**Committee of Experts on the Transport of Dangerous Goods
and on the Globally Harmonized System of Classification
and Labelling of Chemicals**

**Updating of the third revised edition of the Globally
Harmonized System of Classification and Labelling of
Chemicals (GHS): Physical hazards**

**Clarifications to the proposal in ST/SG/AC.10/C.3/2010/69 –
ST/SG/AC.10/C.4/2010/9**

Transmitted by the expert from the United States of America

Decision logic 2.2 (b)

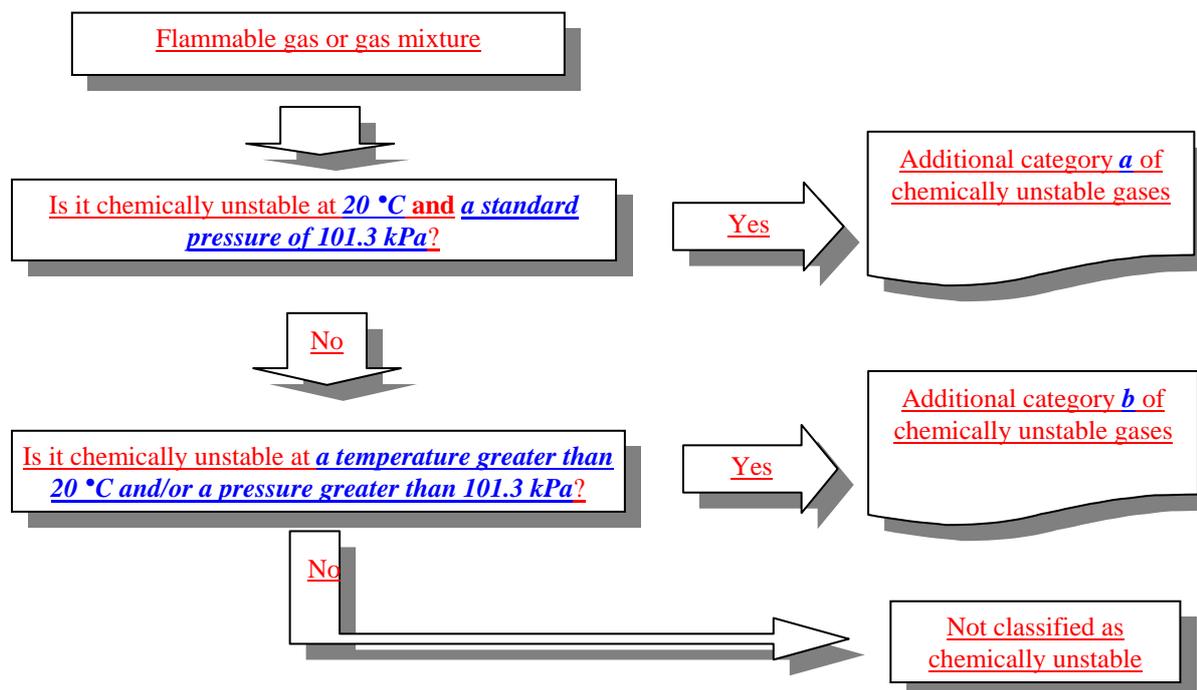
- Section logic 2.2(b): The proposed decision logic is modified to reflect the changes identified above.
